June 25, 2020

La Jolla Community Planning Association

Re: CASS RESIDENCE (Formerly K-4 RESIDENCE)
7595 Hillside Drive
Project No. 522708

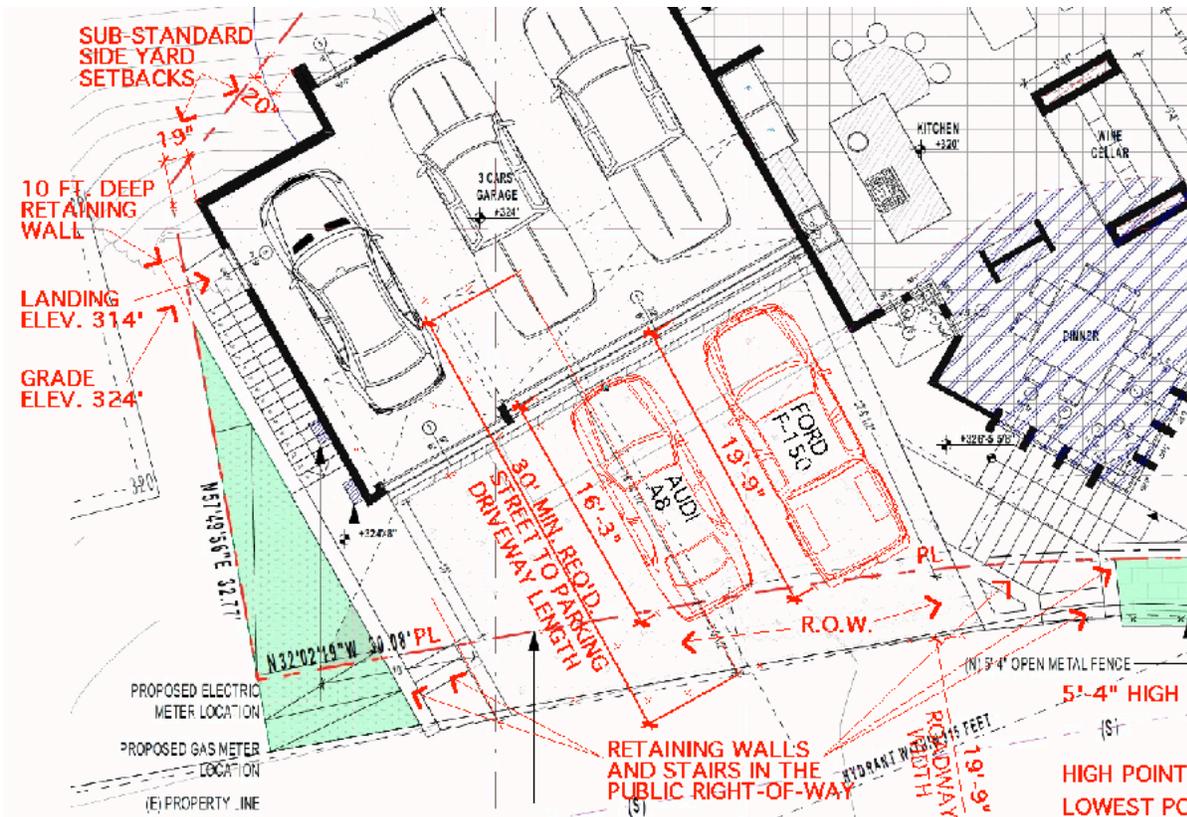
Contrary to the Parking Regulations SDMC Sec. 142.0521(f) the applicant proposes a substandard driveway length which fails to provide the required 30 foot minimum driveway length and 20 foot minimum property line to garage length fails to provide two off-street out of the public right-of-way guest parking spaces.

Aerial view of the existing red brick paving out-of-the-roadway parallel parking spaces to be eliminated by the proposed design.

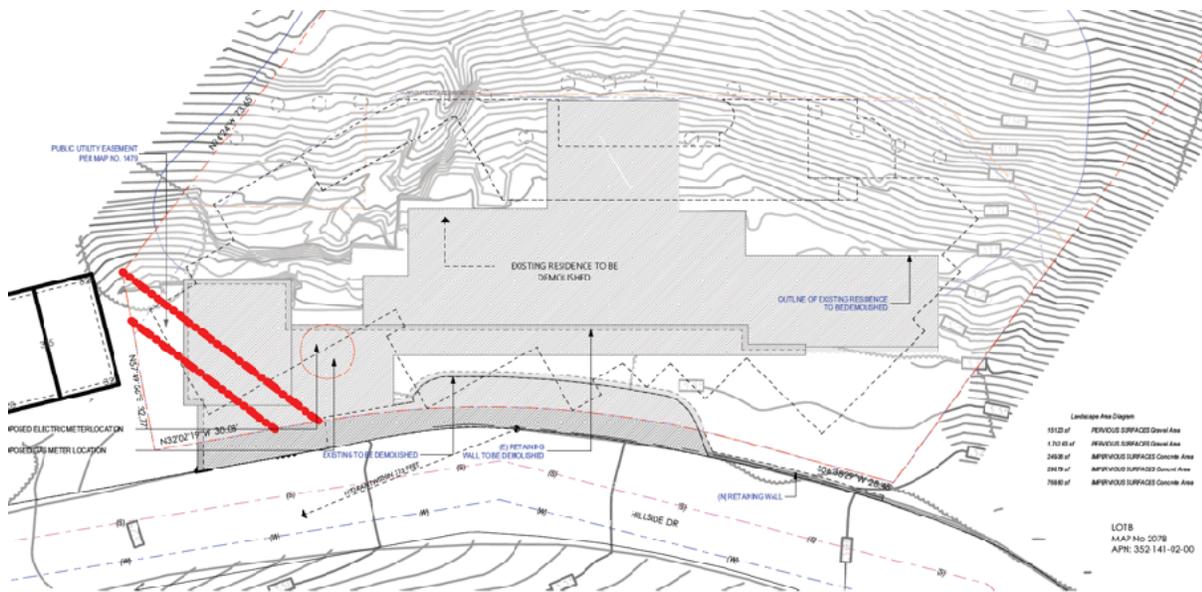
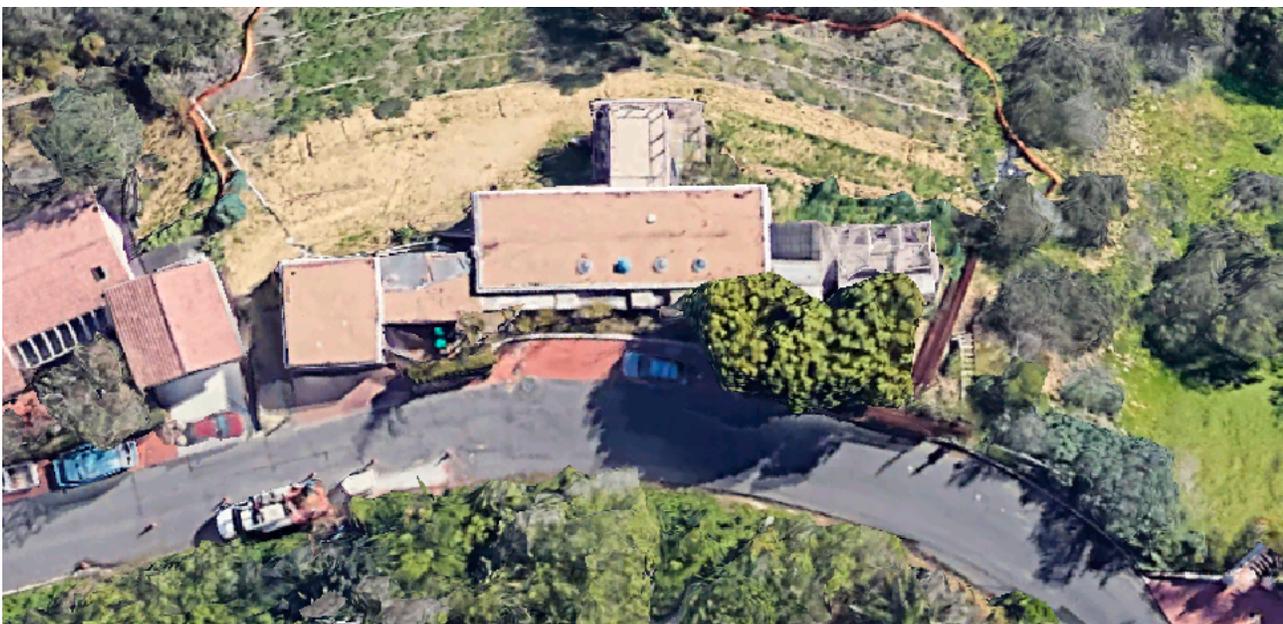
Contrary to the above requirement, the project eliminates of two existing badly needed parallel out-of-the-roadway parking spaces on the narrow 19'-9" wide roadway, shown on the exhibit and aerial photo below:

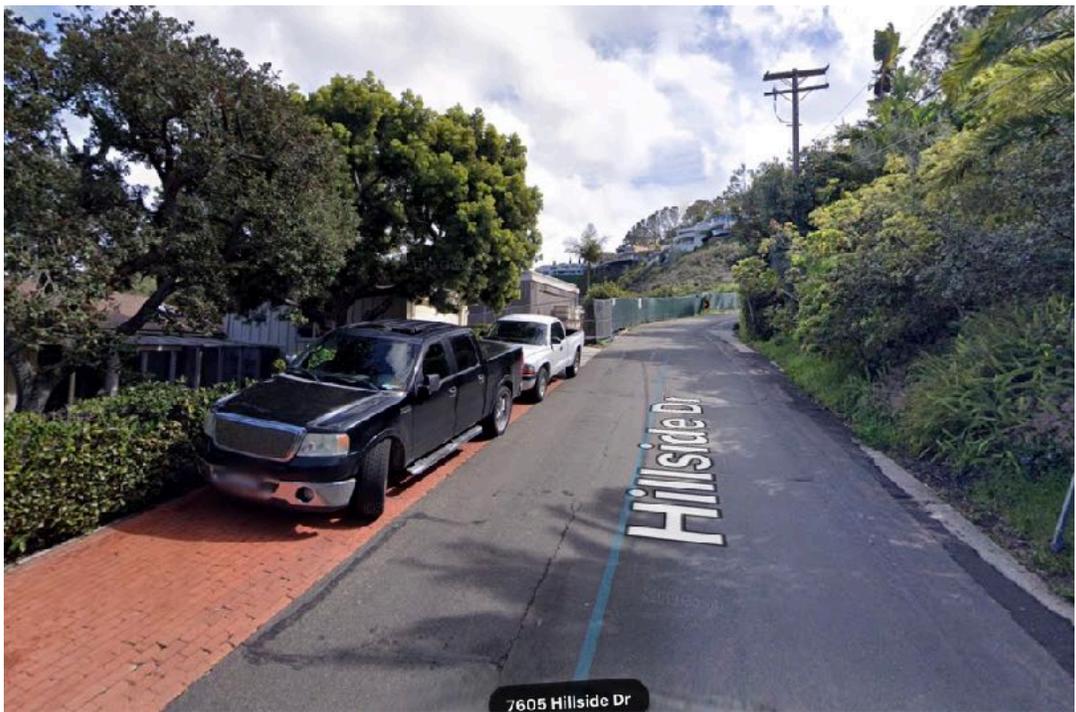
Looking West (downhill) on Hillside Drive. The temporary construction fence obscures the two existing and required out-of-the-roadway parallel parking spaces.

Looking East (uphill) on Hillside Drive toward the proposed project. The existing out-of-the-roadway parallel parking spaces in the foreground are in front of the adjacent property at 7605 Hillside Drive. The subject property is in the distance behind the green construction fence.

3. **DRIVEWAY GRADIENTS of 33, 31 AND 33 PERCENT EXCEED THE MAXIMUM ALLOWED GRADIENT of 20 PERCENT**

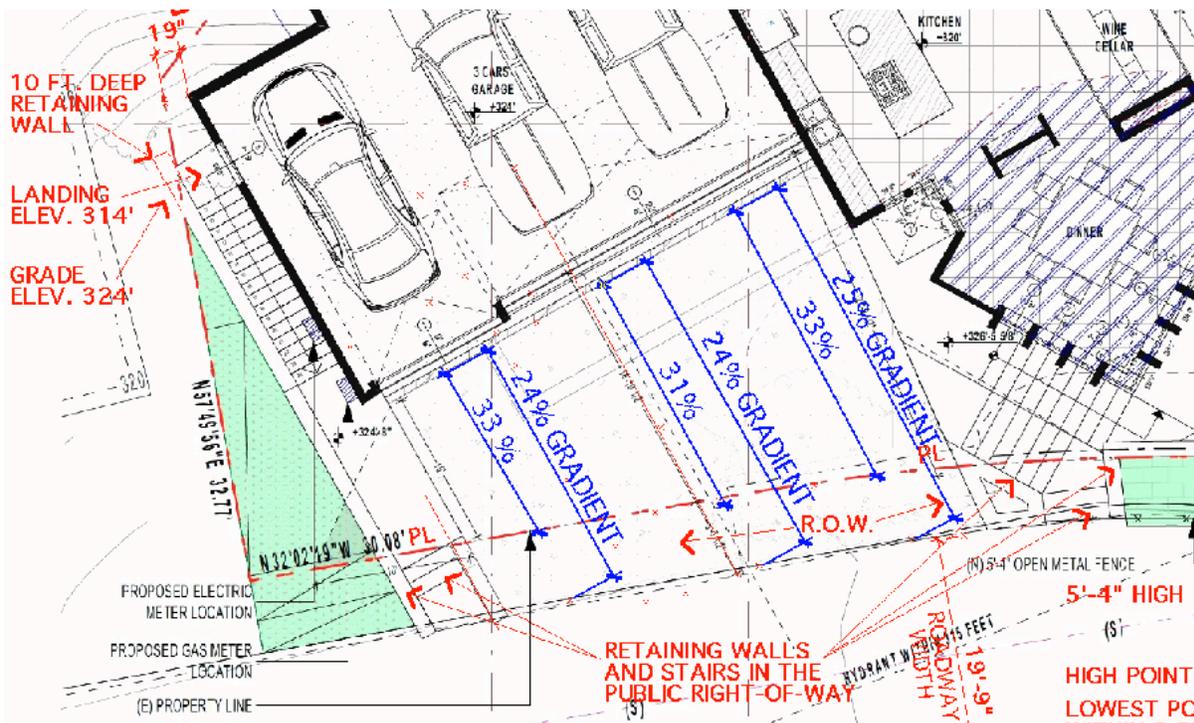
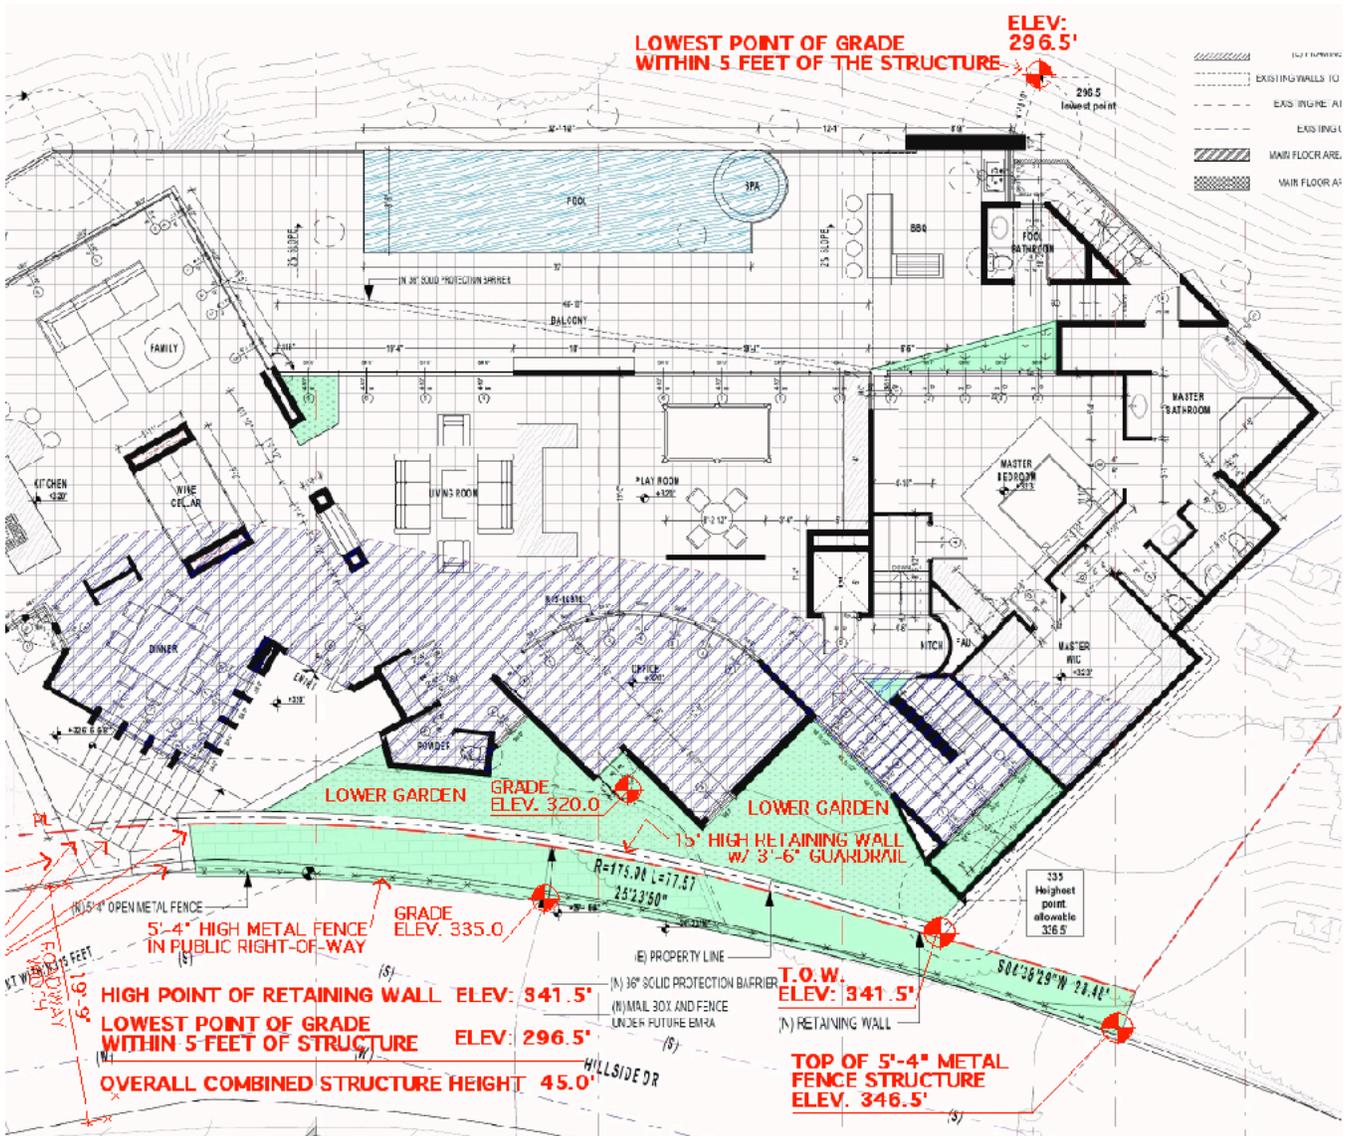
For purposes of driveway gradient calculation, driveway lengths are measured from the front property line to the garage. Per SDMC Sec. 142.0560(j)(9)(C), the maximum permitted slope gradient for a driveway is 20 percent.

The western portion of the proposed driveway is just 12 feet in length from the front property line to the drainage channel. From the topographic information on the designer's drawings, existing grade level of the street adjacent the west side of the driveway is Elev. 328'. The proposed garage floor is at Elev. 324' for a difference in vertical height of 4 feet. The driveway would necessarily slope downward a vertical distance of 4 feet over a horizontal driveway length of 12 feet for a driveway gradient of **33 percent** without transitions. The SDMC states that driveways with slopes greater than 14 percent shall have transitions at the first and last 8 feet of the driveway. As the combined length of the required transitions alone would be 16 feet and where the overall drive length is just 12 feet, the western portion of the driveway is unpassable and does not comply with the SDMC.

The driveway in front of the middle parking space is just 16'-10" in length. The existing grade elevation at the street is Elev. 329.5'. The driveway would necessarily slope downward a vertical distance of 5 feet over a horizontal driveway length of say 17 feet for driveway gradient without transitions in excess of **31 percent**. As the combined length of the required transitions alone would be 16 feet and where the overall drive length is just 17 feet, the center portion of the driveway is unpassable and does not comply with the SDMC.

Additionally, the eastern portion of the driveway is just 22' in length. The existing grade elevation at the street is Elev. 330.5'. The driveway would necessarily slope downward a vertical distance of 6.5 feet over a horizontal driveway length of 20 feet for driveway gradient without transitions of **33 percent**. As the combined length of the required transitions alone would be 16 feet and where the overall drive length is just 23 feet, the eastern portion of the driveway is unpassable and does not comply with the SDMC.

Even if the driveway gradients were calculated from the edge of the street pavement to the drainage channel, the slope gradient of the three portions of the driveway from west to east would be **24 percent, 24 percent, and 25 percent**, and would still be unpassable and substantially exceed the maximum permitted driveway gradient of **20 percent** per SDMC Sec. 142.0560(j)(9)(C).

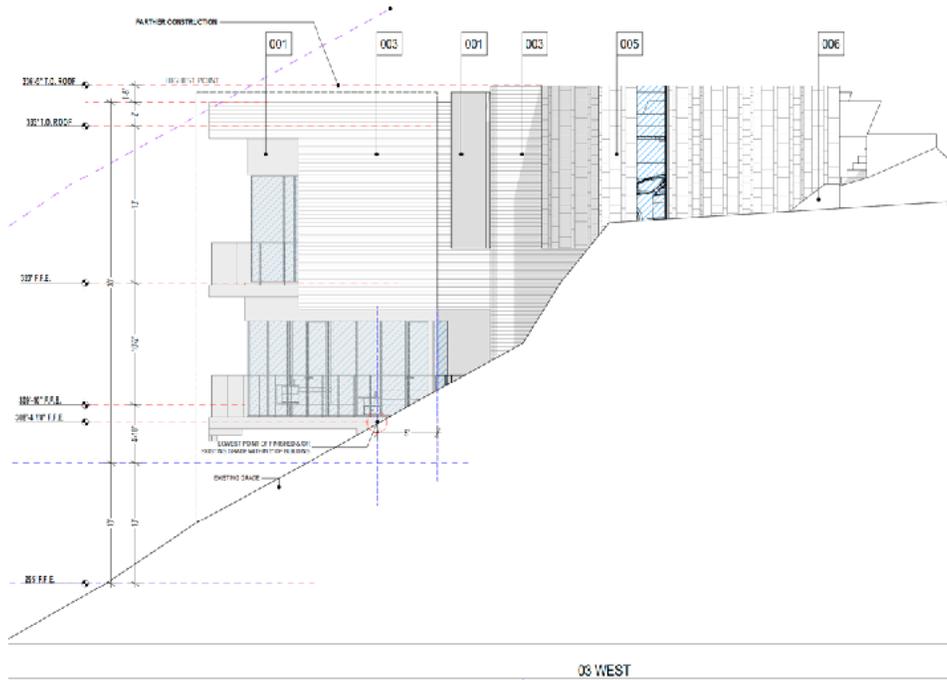
The solid dark grade line on the designer's 03 WEST Elevation drawing below depicts existing grade along the western side property line. The exterior stairway that connects the exterior terrace at the Ground Floor Level, with garage floor and driveway above at the Upper Floor Level, are **not** shown on the applicant's 03 WEST Elevation.

Had the designer's 03 WEST Elevation drawing shown the proposed stairway adjacent the west exterior wall of the garage, as depicted on the Garage Plan below, one would clearly see that the proposed stairway and landing would be deep below existing grade level. An analysis of the stairway shows that the elevation of the intermediate stair landing adjacent the side property line is roughly Elev. 313.78' where the existing grade level on the adjacent property is Elev. 324'; which places the stair landing more than 10 feet below the existing adjacent grade level.

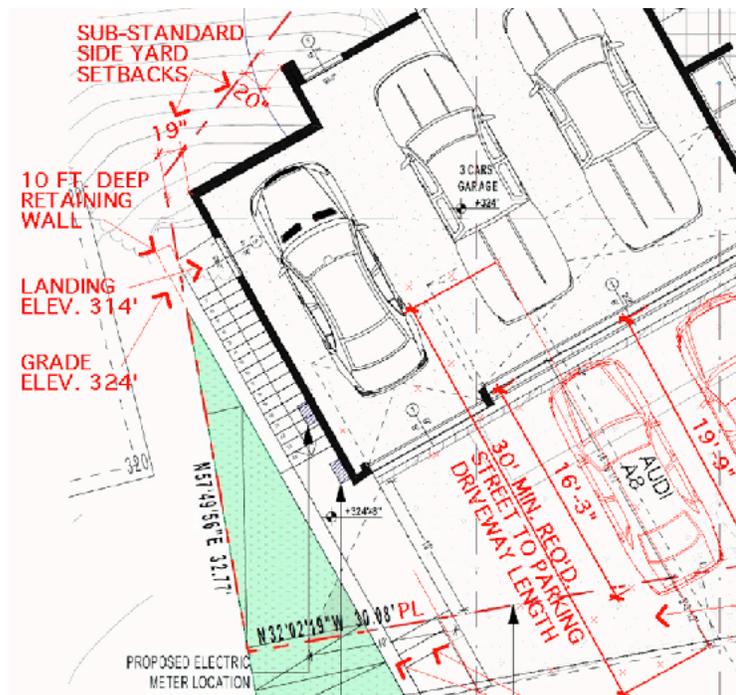
The new retaining wall along the west side of the exterior stair is shown on the preceding Garage Plan. To accommodate the below grade stairway and landing the retaining wall and footing would necessarily have to extend onto the adjacent property. (see **dashed red lines** on preceding Plan) However, the necessary retaining wall simply disappears at the side property line on the designer's preceding Floor Plan drawing. The necessary site retaining wall is **omitted** from designer's Site Plan and Ground Floor Plan drawings.

In order to construct the below grade exterior stairway as shown, a new 10+ ft. high retaining wall and footing will necessarily extend onto the adjacent property, which is **prohibited** by the City of San Diego.

8. PROPOSED 5'-4" METAL FENCE WITHIN THE PUBLIC RIGHT-OF-WAY NOT DESCRIBED

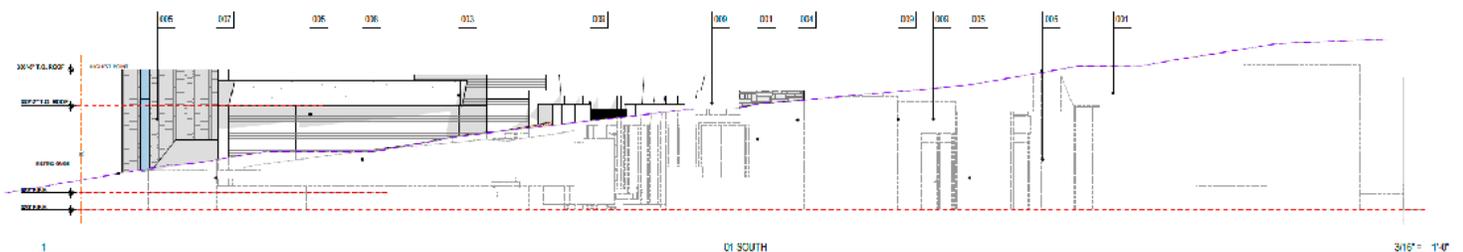
Omitted from the applicant's digital drawings submitted to the LJCPA is an Elevation from the street showing the proposed 5'-4" high open metal fence entirely within the public right-of way and immediately adjacent the paved roadway. Because the roof levels of the eastern half of the dwelling are well below street level as illustrated by the dashed blue line on the South Elevation below, the proposed 5'-4" open metal fence will constitute most of what will be seen from the street.

An elevation drawing from the street looking at the project should show the proposed design of the 5'-4" high open metal fence. Without a design for the open metal fence, one might assume the proposed fence may look like the open metal fences at K-4 RESIDENCE property owner Mark Kooklani's three previous projects at 7447, 7451 and 7455 Hillside Drive.

9. ENVIRONMENTAL IMPACT OF THE PROPOSED DEVELOPMENT ON THE SEASONAL WETLAND NOT YET CONSIDERED

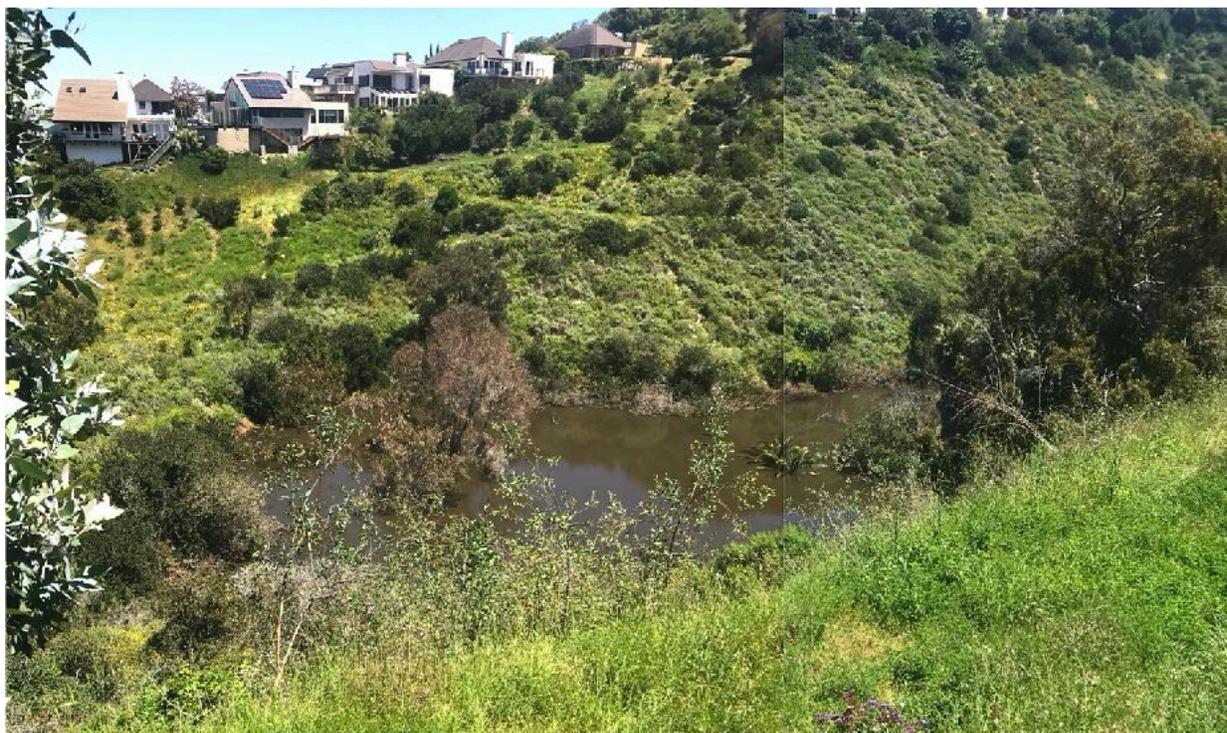
A lower portion of the project site lies within a sizable seasonal wetland. Because the LDR - Environmental Review Section of the DSD has yet to receive certain Environmental Studies from the applicant, the environmental impact of the proposed development on the sensitive wetland environment has not yet been considered.
